**Town of Kittery  
Planning Board Meeting  
October 13, 2022**

**ITEM 3 – 41 Route 236 – Preliminary Site Plan Review**

**RE: Town of Kittery, Planning Board Services  
Preliminary Site Plan Review  
Well Field 44 Cannabis Dispensary, 41 Route 236, Tax Map 29, Lot 1  
CMA #591.150**

SCALE: 1" = 40'	APPROVED BY:	DRAWN BY: MJS
DATE: 04/26/22	FILE: WF44 DEV.BASE.DWG	REVISION DATE: D : 09/29/22
JOB NO: C277-21	SHEET: 1

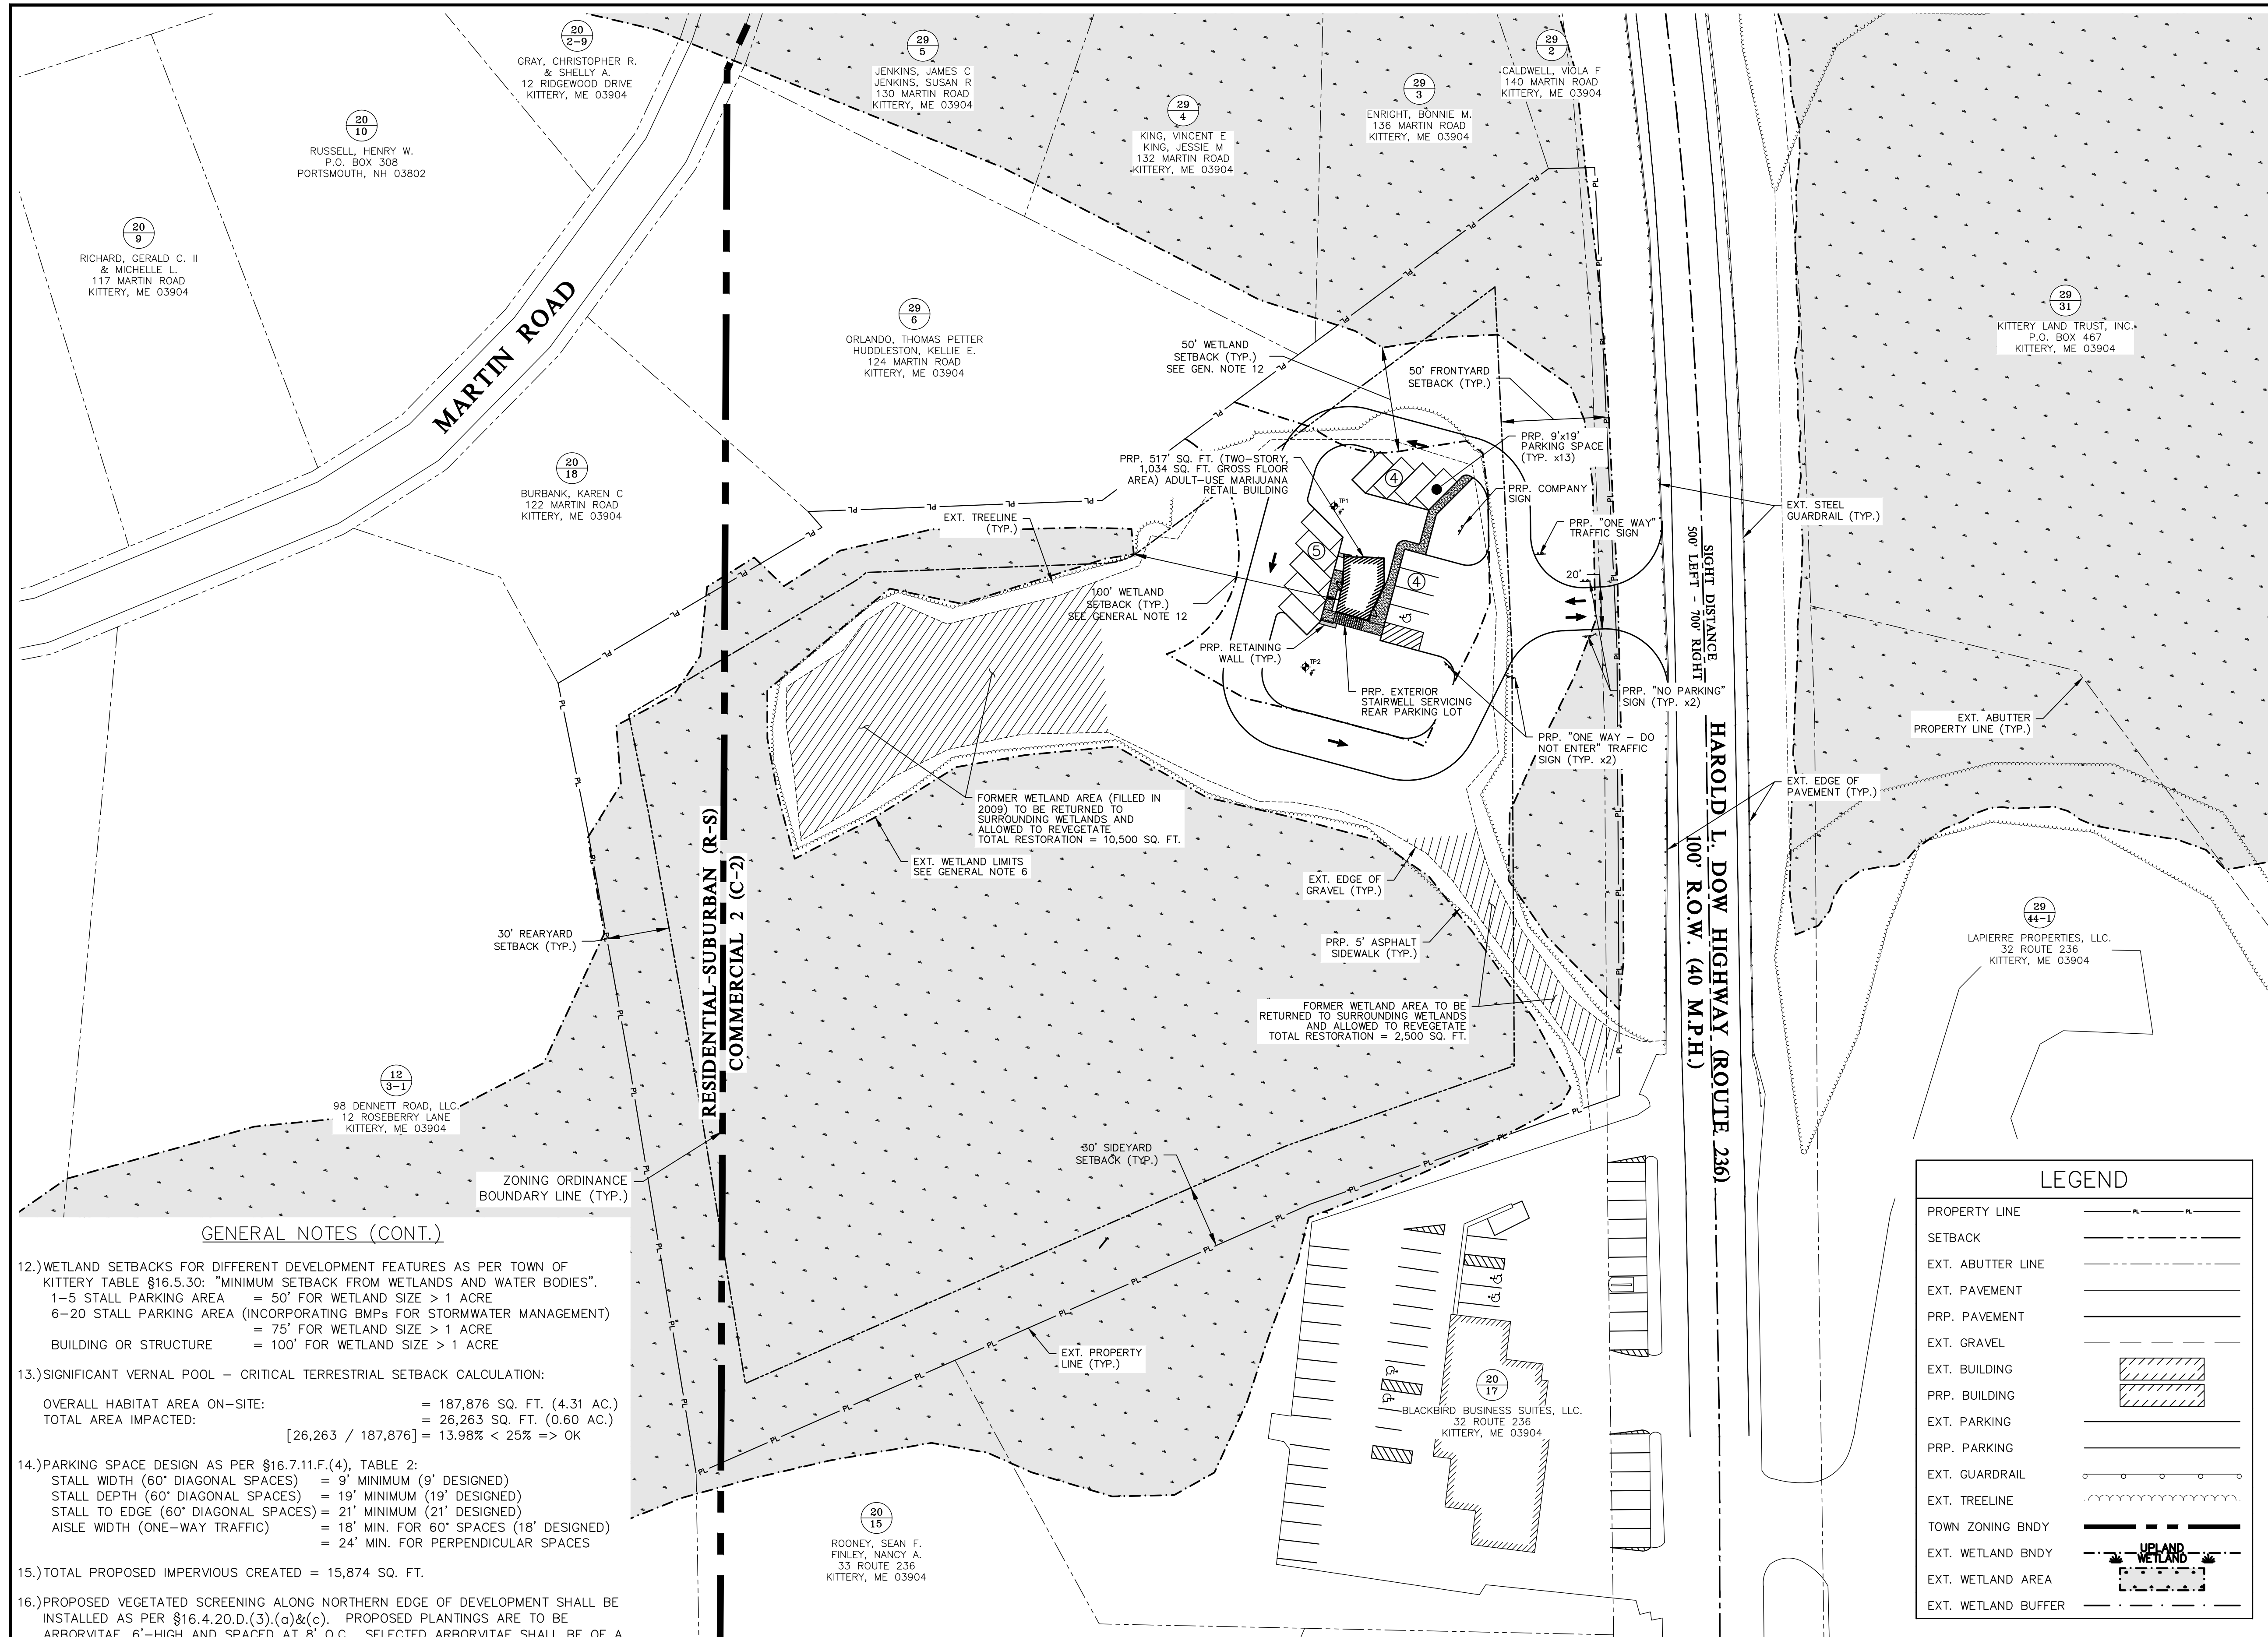
#### Sheet 1-Preliminary Site Plan:

- Does the proposed exterior stairwell provide handicapped access to the entrance at the rear of the building? If not, how is handicapped access provided?

- Note 11 references a hydrant on Sheet 3 but none is shown.
- General Note 16 states that “specific planning (sic) locations shall be determined in a post-construction buffer survey”. The applicant should show the proposed locations and number of screening plants on the proposed landscaping plan and not determine this later.

SCALE: 1" = 20'	APPROVED BY:	DRAWN BY: MJS
DATE: 04/26/22		REVISION DATE: D : 09/29/22
JOB NO: C277-21	FILE: WF44 DEV BASE.DWG	SHEET: 3

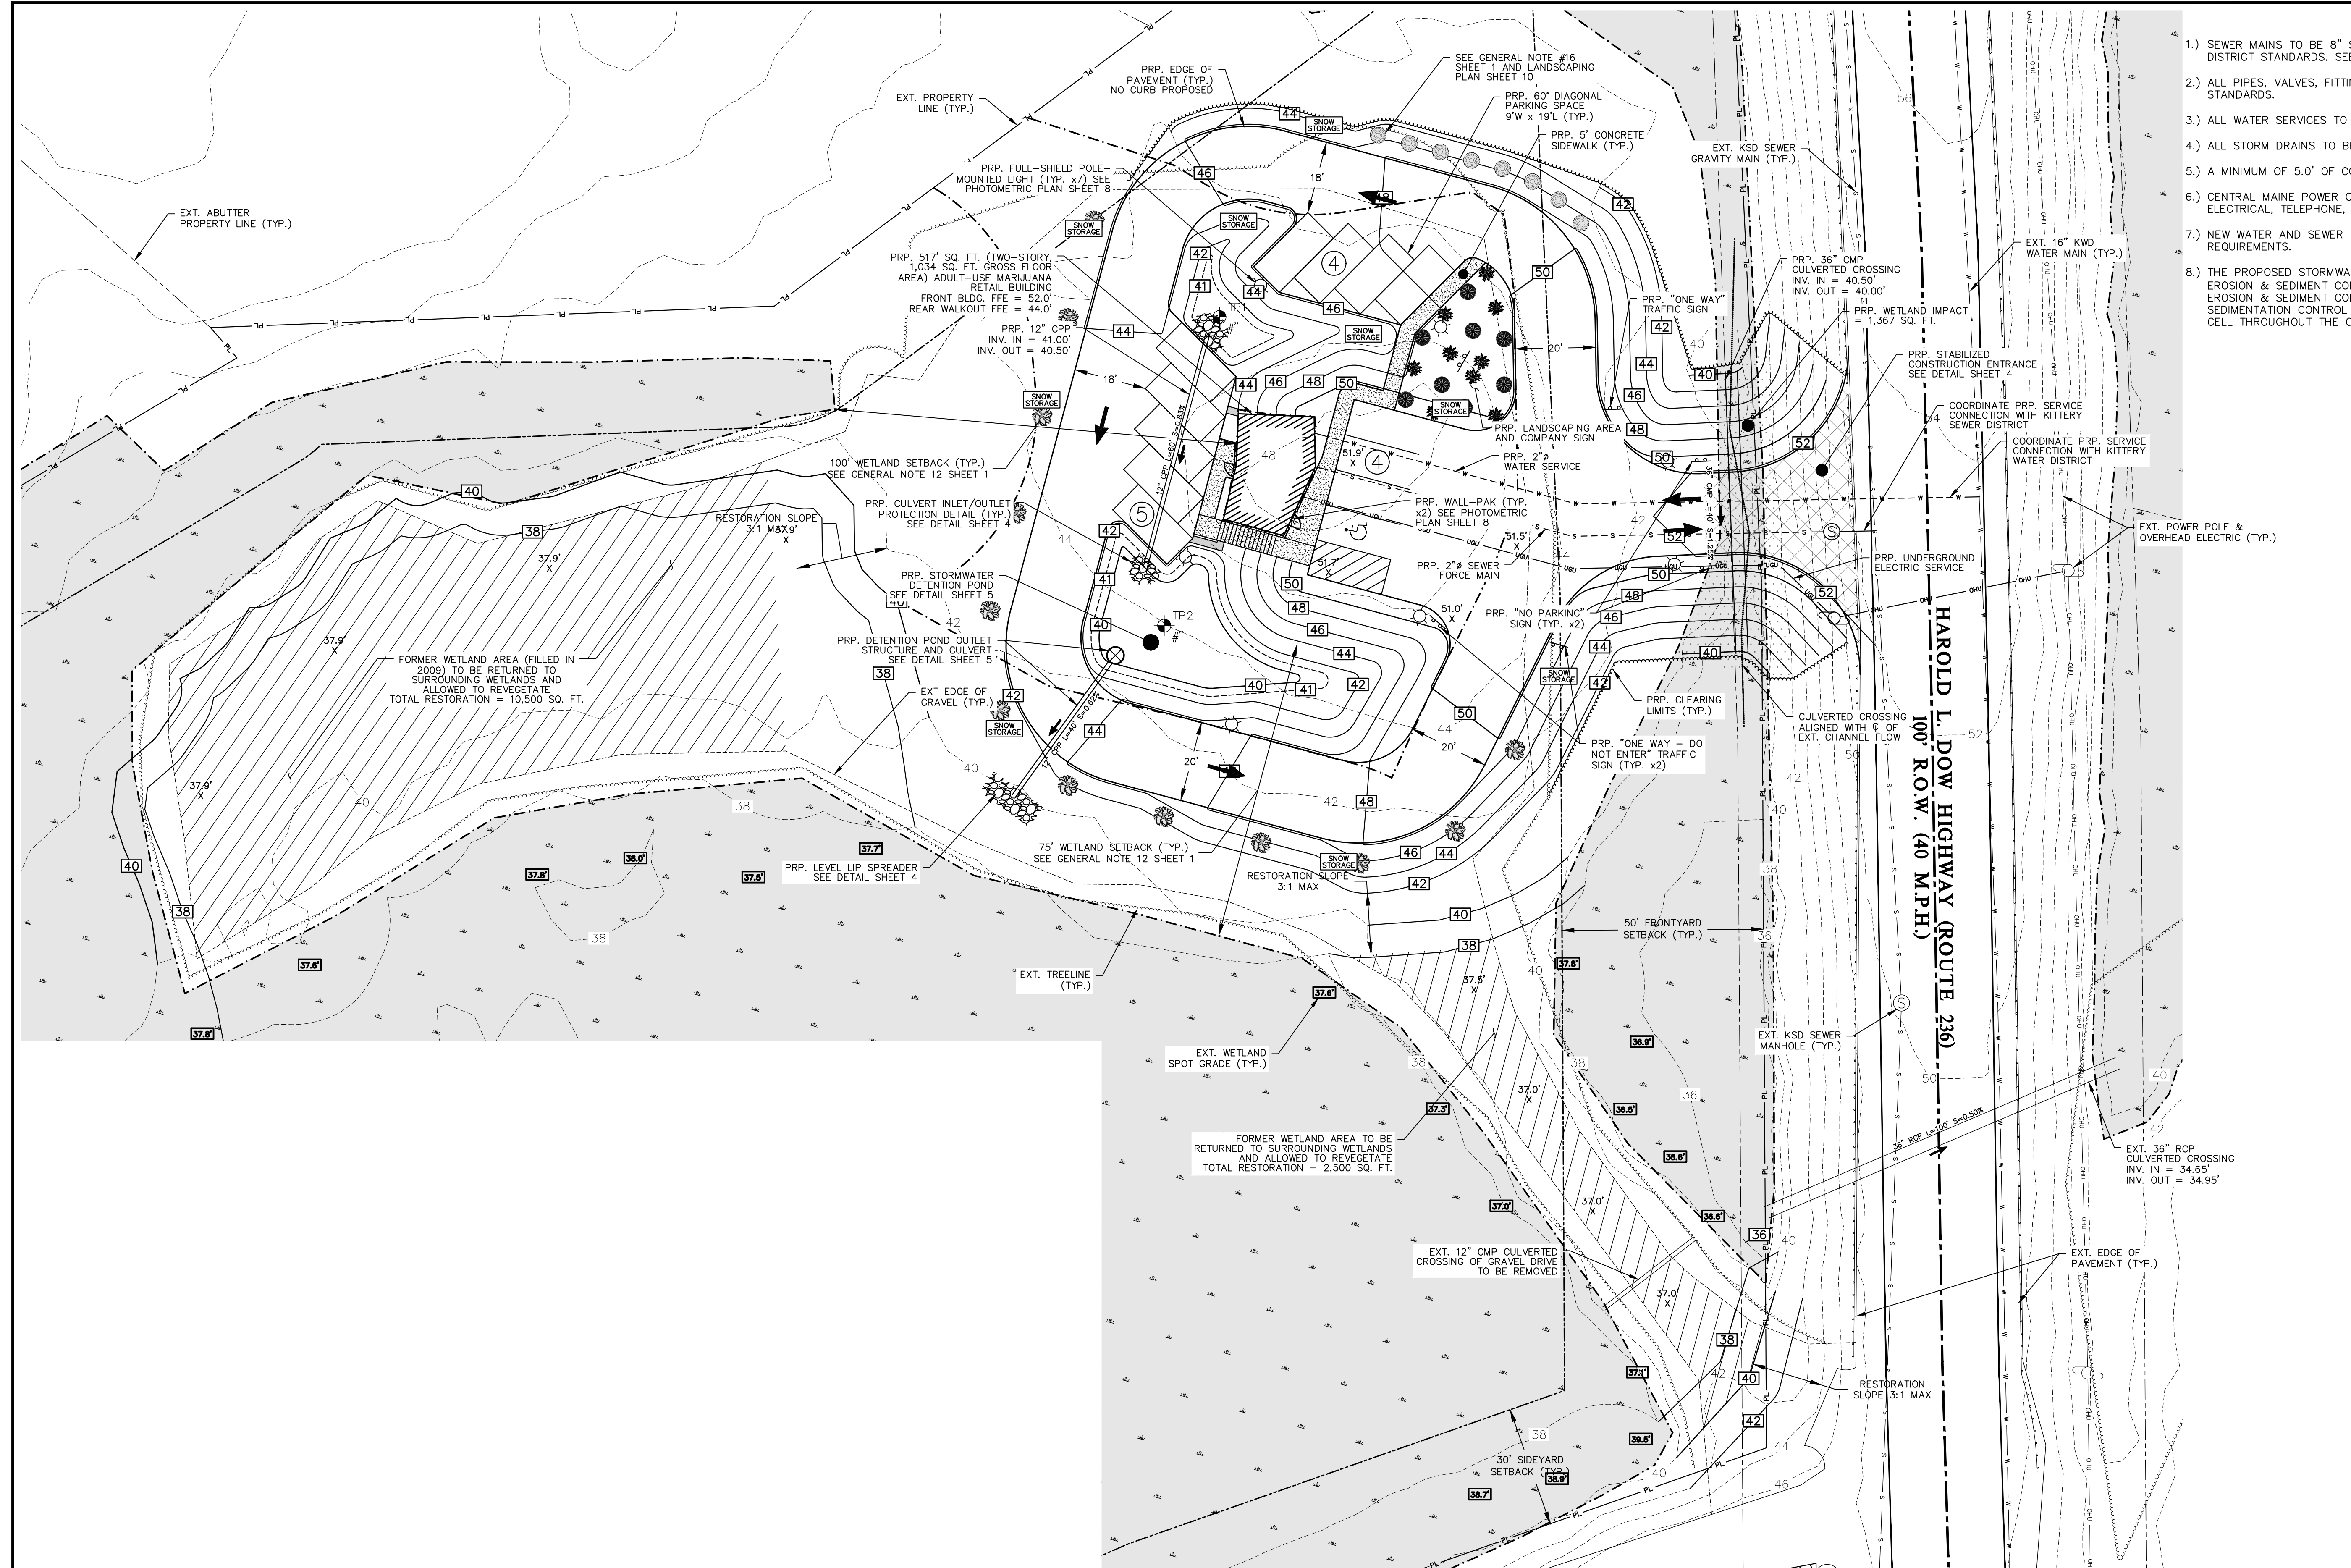
#### Sheet 3-Grading and Utilities Plan:

- Change references from Kittery Sewer District to Kittery Sewer Services.
- There is a section of proposed sewer forcemain proposed. Have design details been provided to Kittery Sewer Services for review?
- The proposed sewer manhole inverts should be shown on the plan.
- Notes 1 and 3 mention multiple sewer mains and water services when one of each is proposed.
- Note 11 on Sheet 1 references a hydrant but none is shown.
- The proposed retaining wall should tie into proposed contours. Top and bottom of wall elevations or spot grades would be helpful.

**ROAD CROSS SECTION (WETLAND CROSSING AT ENTRANCE)**  
SCALE: (NTS)  
GRAVEL FILL TO BE COMPACTED TO 95% MODIFIED PROCTOR

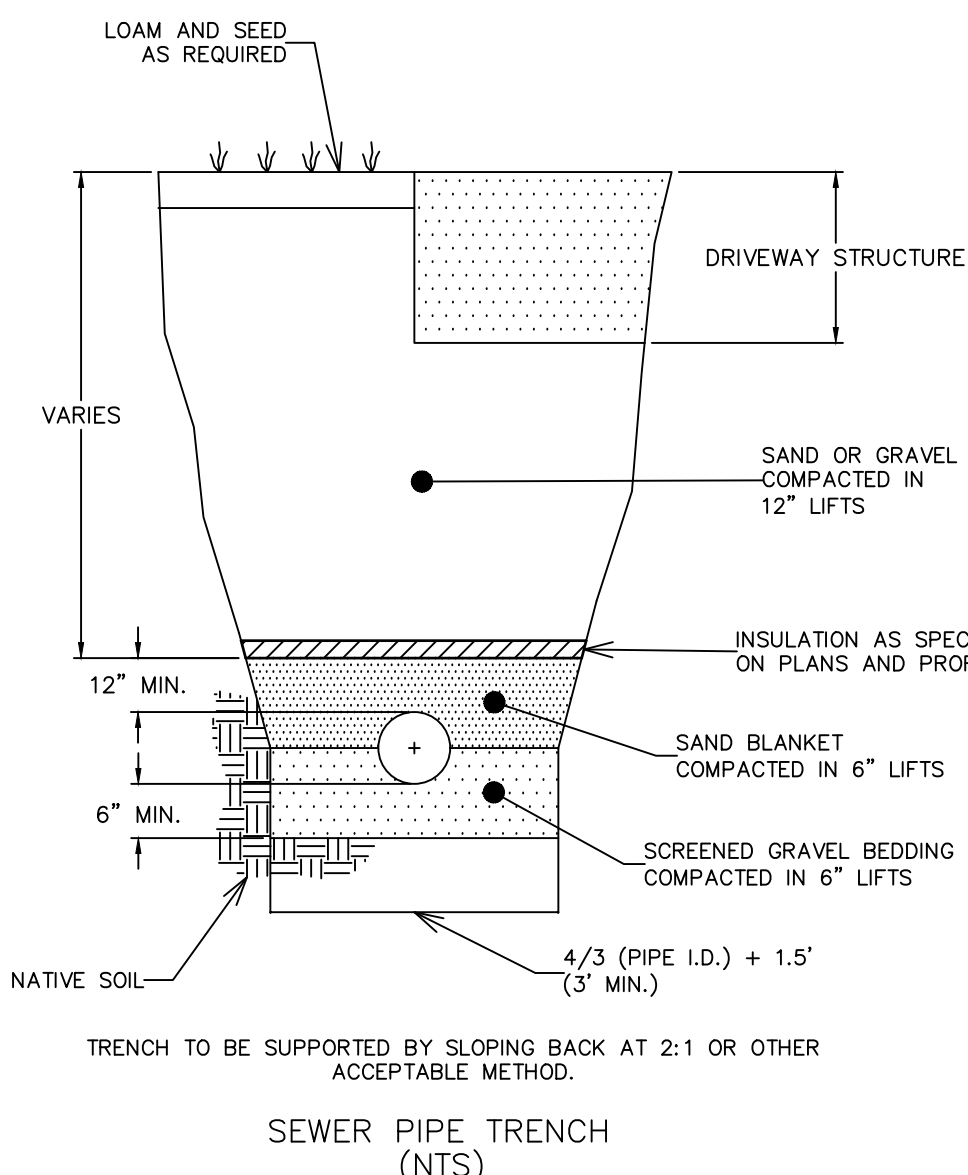
- Provide a trench patch detail for work in Route 236.
- The road cross section (wetland crossing at entrance) detail should include the 36" pipe.
- The Sewer Pipe Trench detail references "insulation as specified on plans and profiles". There are no profiles and no mention of insulation on the plans.

**TYPICAL SANITARY MANHOLE**  
SCALE: NTS

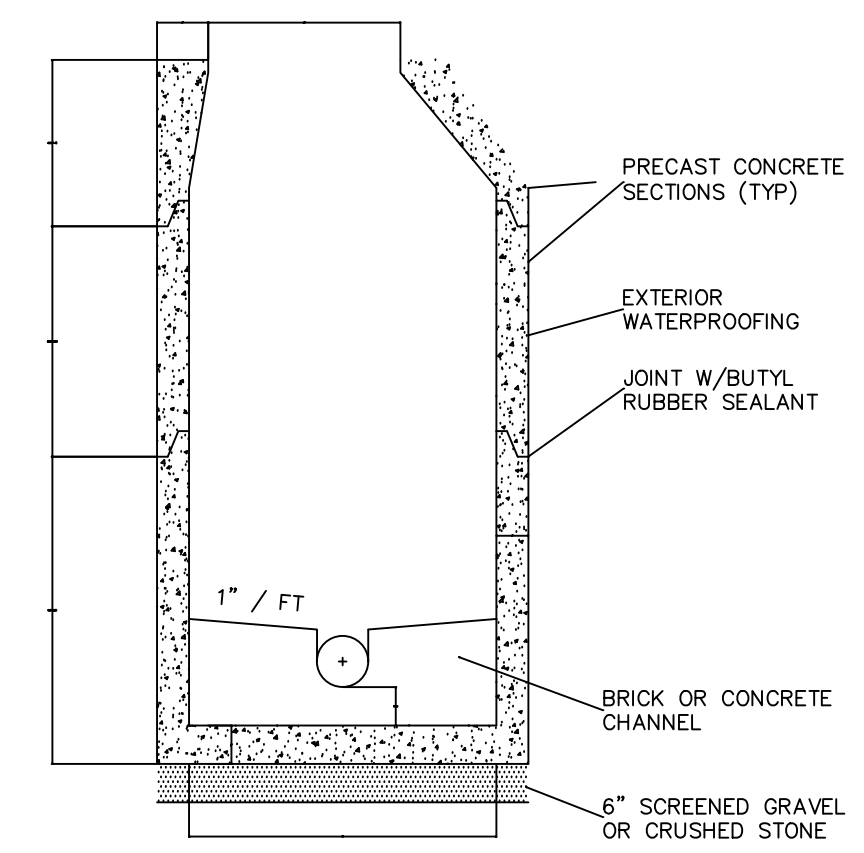
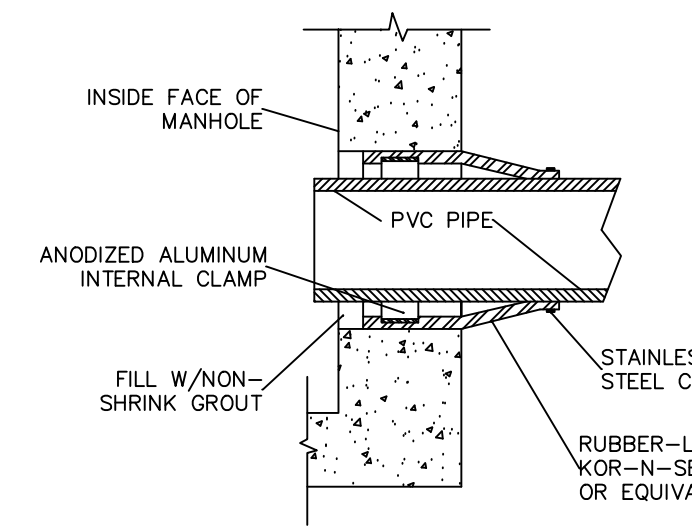
- Is there a catch basin located on site?
- The Typical Sanitary manhole should include notes about compaction for gravel. The forcemain connection should be shown in the detail.
